**DEPARTMENT OF TRANSPORTATION****Federal Railroad Administration****49 CFR Part 213**

[Docket No. FRA–2018–0104]

**Rail Integrity Amendments & Track Safety Standards**

**ACTION:** Notice of proposed rulemaking (NPRM).

Figure 1

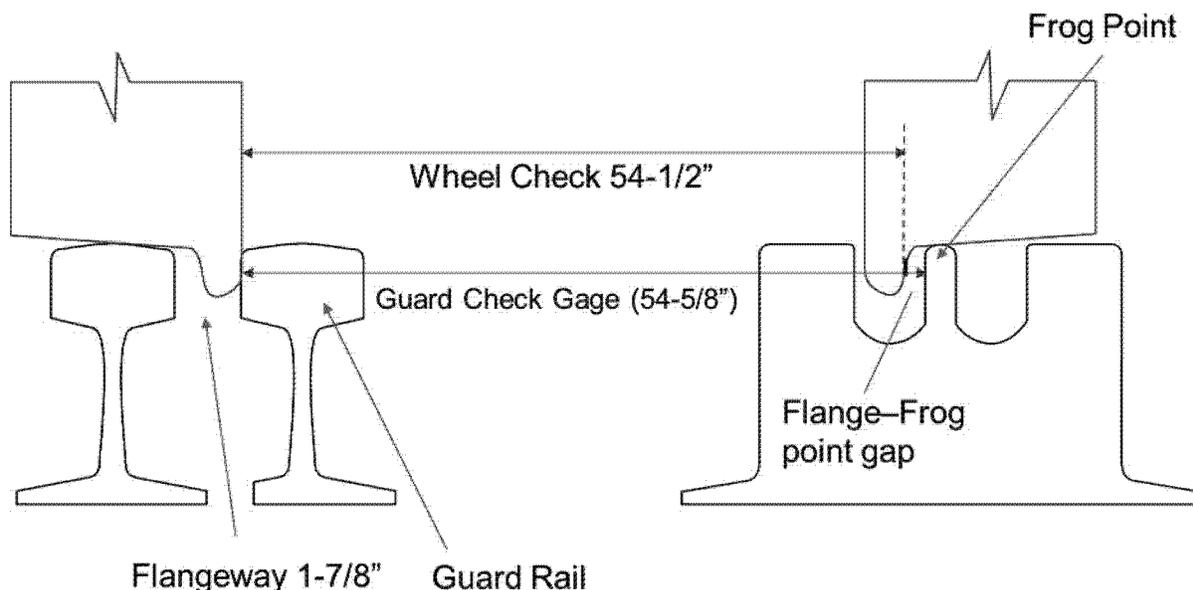
Figure 1 depicts a standard frog, which has a standard guard check gage of 54.625", meeting the requirement for Class 5 track (greater than or equal to  $54\frac{1}{2}$ " or 54.5"). A heavy-point frog has a standard guard check gage of 54.4531",

which does not meet current FRA standards for Class 5 track but does

meet the current standards for Class 4 track (greater than or equal to 54.375").

In 2003, FRA approved a waiver permitting operation of trains at Class 5 track speeds over certain HPFs at which the guard check gage, under existing 49 CFR 213.143, conforms to the standards applicable to Class 4 track. See docket number FRA-2001-10654 (available online at [www.regulations.gov](http://www.regulations.gov)). Among other conditions to ensure safety, the waiver requires that the frog, and the guard rails on both tracks through the turnout containing the frog, be equipped with at least three through-gage plates (metal plates underneath the frog that expand across the entire frog to provide both vertical support and lateral restraint for the frog components) with elastic rail fasteners and guard rail braces that permit adjustment of the guard check gage without removing spikes or other fasteners from the crossties. The waiver also requires that track owners retain records of the location and description of each turnout containing an HPF, notify FRA prior to operating trains over a new HPF, and provide proper information and training to any employees designated to inspect or supervise restoration or renewal of areas containing an HPF. Each HPF must also bear an identifying mark. Since FRA initially granted the waiver in 2003, FRA has renewed the waiver three times, most recently on February 15, 2018. The waiver is currently set to expire on February 15, 2023.

To date, no accidents have been reported to FRA as having occurred at or near locations where HPFs are installed. Accordingly, FRA believes that the safety benefits of HPFs have been proven. As discussed in more detail below in the section-by-section analysis for § 213.143, FRA proposes to incorporate the waiver provisions into the regulation.

As discussed in more detail in section IV.C of this NPRM, in 2003, FRA granted a waiver (docket number FRA–2001–10654) to members of the railroad industry allowing operation of trains at Class 5 speeds over a heavy-point frog (HPF) with guard check gages conforming to the standards for Class 4 track frogs. FRA granted three extensions of this waiver, most recently on February 15, 2018, and it will expire on February 15, 2023. After careful review of safety performance under the waiver and analysis of track-caused derailment data, FRA believes that the safety case has been proven and proposes to incorporate the waiver provision into the regulation. Because the performance of the HPFs installed under the waiver is the primary basis for FRA’s conclusion that these frogs are safe, FRA believes that it is in the best interests of safety to retain, as much as
